SHOAL CREEK ADDITION WICHITA, SEDGWICK COUNTY, KANSAS

RE: SUB 2000-22 -- Final Plat of SHOAL CREEK ADDITION (FORMERLY WHITEWOOD ADDITION)

At the regular meeting of the Subdivision Committee of the Metropolitan Area Planning Commission on Thursday, September 14, 2000, the above captioned plat was considered. The action of the Committee was to approve the final plat, subject to the following:

CASE NUMBER: SUB 2000-22 --SHOAL CREEK ADDITION (formerly Whitewood Addition)

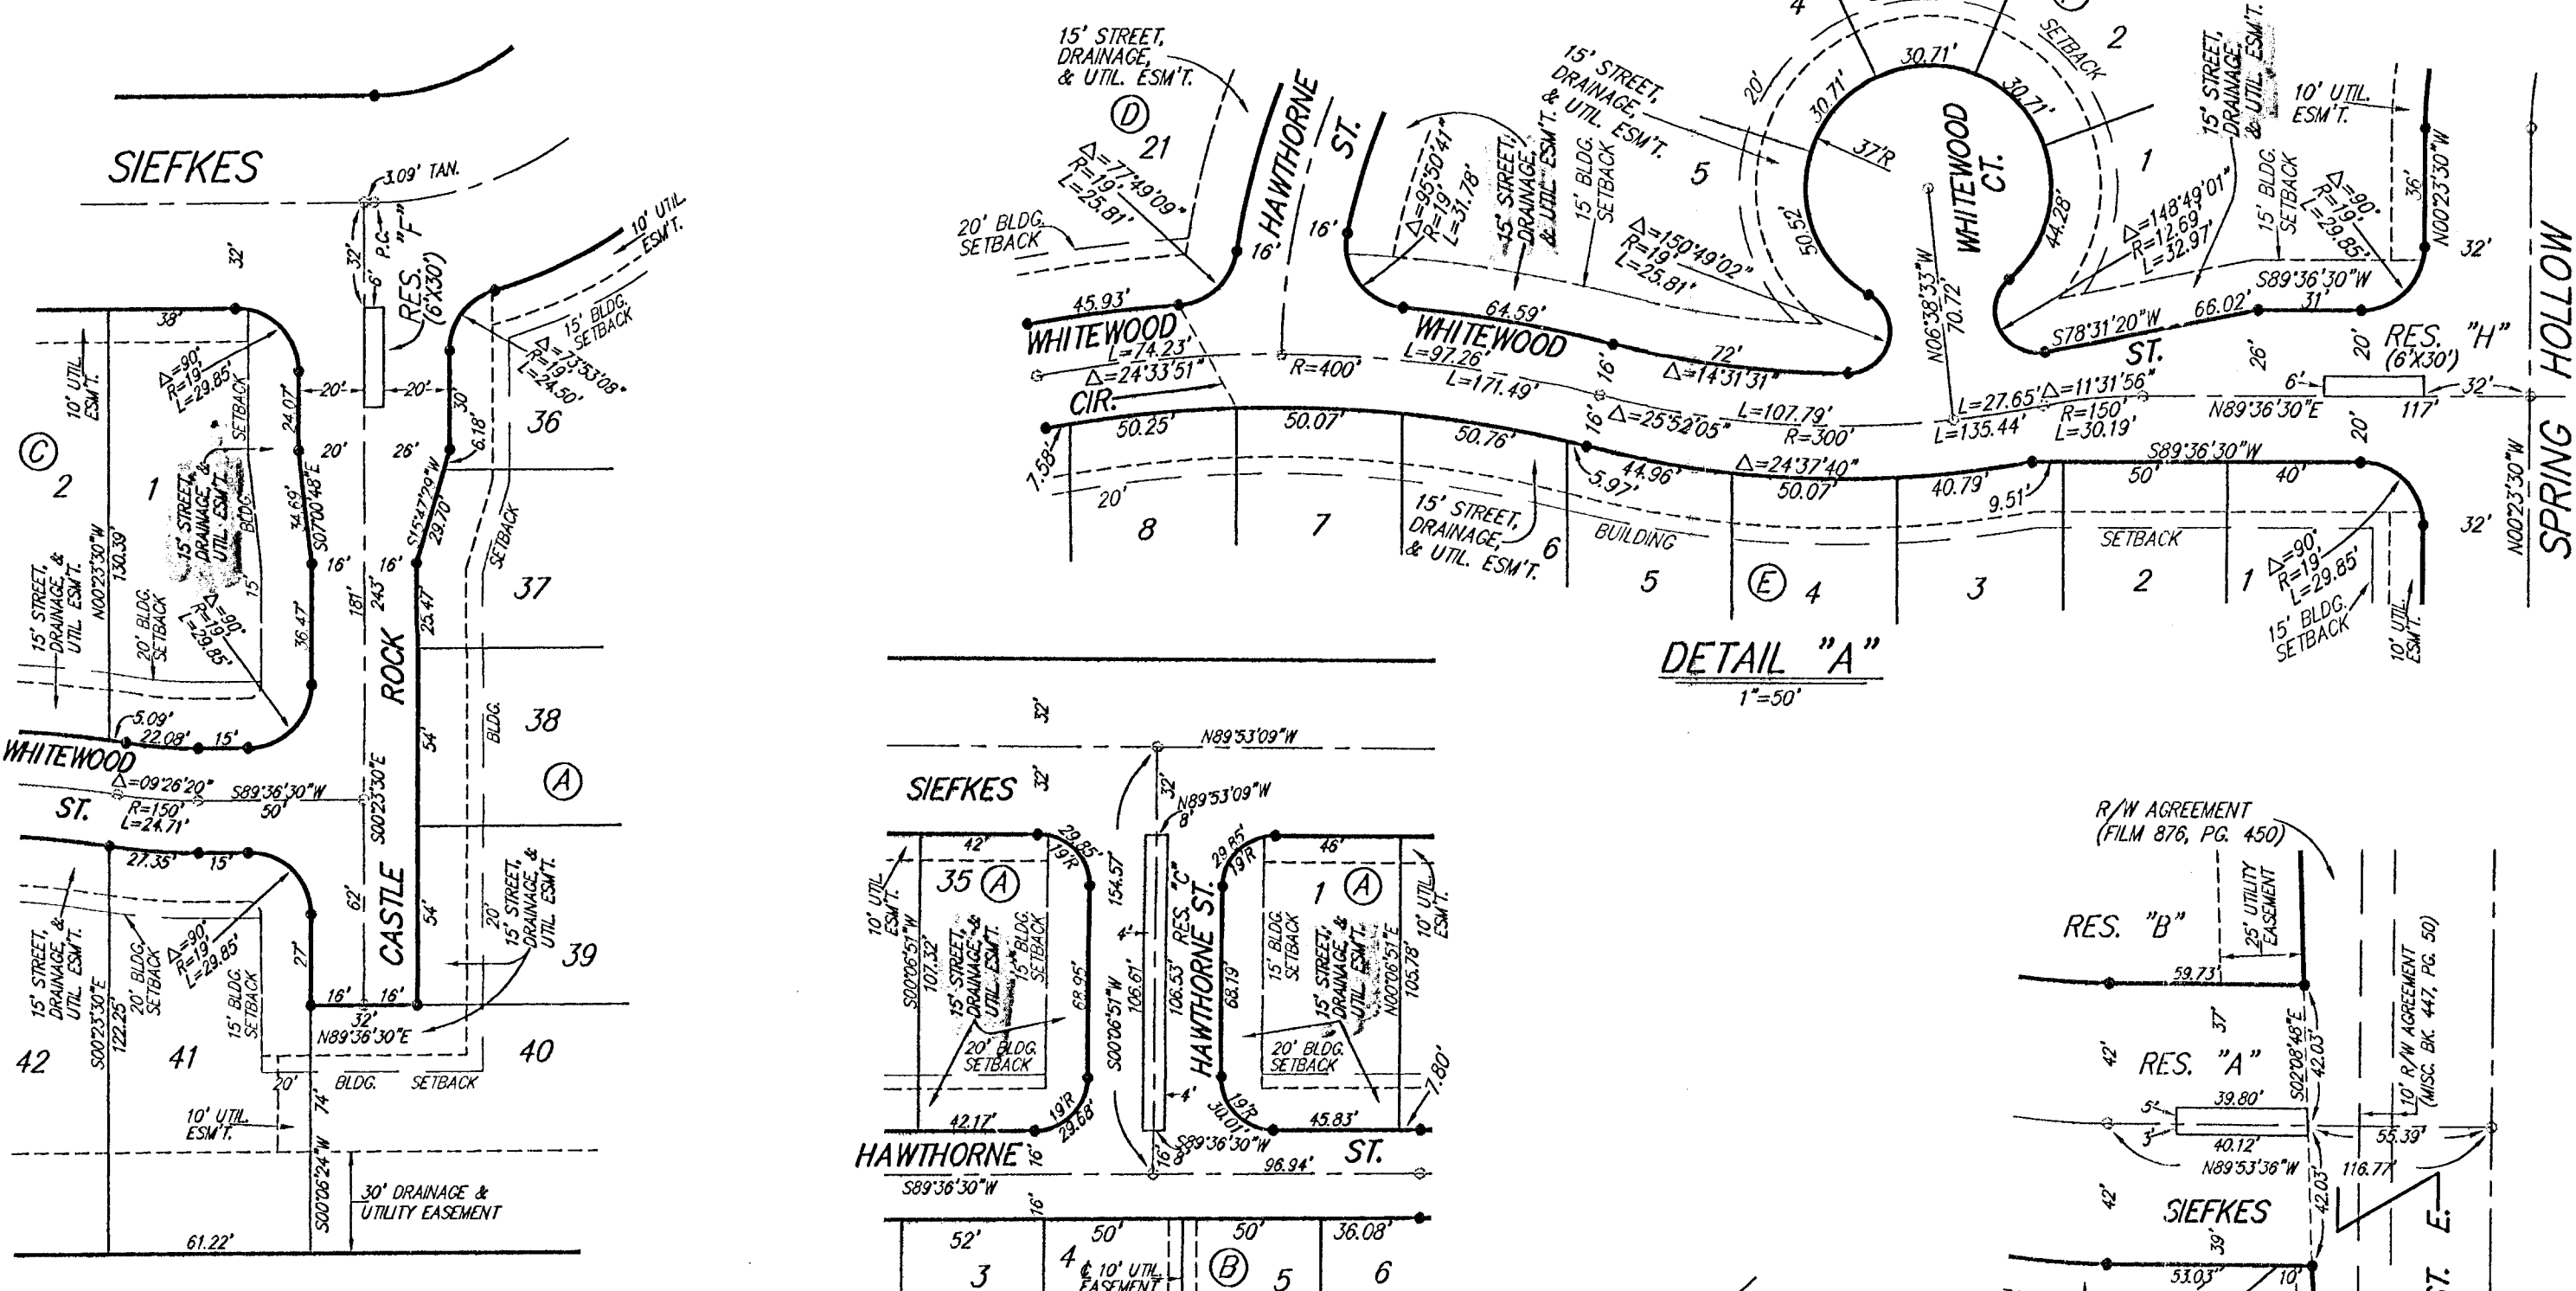
- A. In order to allow for the lot sizes being platted, and since the plat is adjacent to the City of Wichita, the applicant shall request annexation into the City. Upon annexation, the property will be zoned SF-6, Single-Family residential and permit the lot sizes being proposed. The final plat shall not be scheduled for City Council consideration until annexation has occurred.

- B. The applicant shall guarantee the extension of sanitary sewer to serve the lots being platted. This guarantee shall be with the County for service through the Four Mile Creek sanitary sewer system. On the final plat tracing, appropriate wording shall be added to the Mayor's signature block indicating the City's agreement to allow a County sewer district to be formed within the City. **A revised sanitary sewer/utility layout is requested. Off-site sewer easements are required.**

- E. **City/County Engineering** needs to comment on the status of the applicant's drainage plan. **A drainage guarantee is required. As drainage from the site is directed onto the Kansas Turnpike, a letter shall be required from KDOT indicating their agreement to accept such drainage.**

- F. Complete access control is required along the Kansas Turnpike. The dedication of access controls shall be referenced in the plat's text on the final plat.

- G. City Fire Department needs to comment on the 2,400-ft cul-de-sac (Siefkes/Whitewood Court) which exceeds the 1,200 maximum length standard of the Subdivision regulations. City Fire Department requests an emergency access easement to provide two points of access along Reserve D, Block A.

- K. The MAPC Policy Statement regarding Cluster Development states that each open space area shall be a minimum of 10,000 square feet and that no lot reduced in area shall be more than 500 feet from the nearest open space area. Lots 36-39, Block E are not located within the required 500 feet from Reserve E. A modification from this design standard has been approved.

- M. The lots in Block E shall be renumbered beginning with Lot 1.
- N. The terminus of Whitewood Court to the west shall be reconfigured as a circular turnaround.

- O. Traffic Engineering needs to comment on the need for improvements to 143rd St. East. Traffic Engineering has required the construction of a decel lane.

- Q. The pipeline easement on Lot 26, Block E, needs to be located.
- R. A dimension needs to be added on Lots 5 and 6, Block D.

- S. Since this plat proposes the platting of narrow street right-of-way with adjacent "15-foot street drainage and utility easements", a restrictive covenant shall be submitted which calls out restrictions for lot-owner use of these easements. Retaining walls and change of grade shall be prohibited within these easements as well as fences, earth berms and mass plantings.

- T. City Fire Department needs to comment on the plat's street names. The City Fire Department has met with the Applicant to revise the street names.
- U. The applicant shall guarantee the installation of the interior streets. This guarantee shall include a sidewalk along one side of Whitewood/Siefkes. In lieu of sidewalks on Siefkes Court and Whitewood Place/Whitewood Court, the Applicant has agreed to submit an alternate sidewalk plan denoting sidewalks around Reserve E.
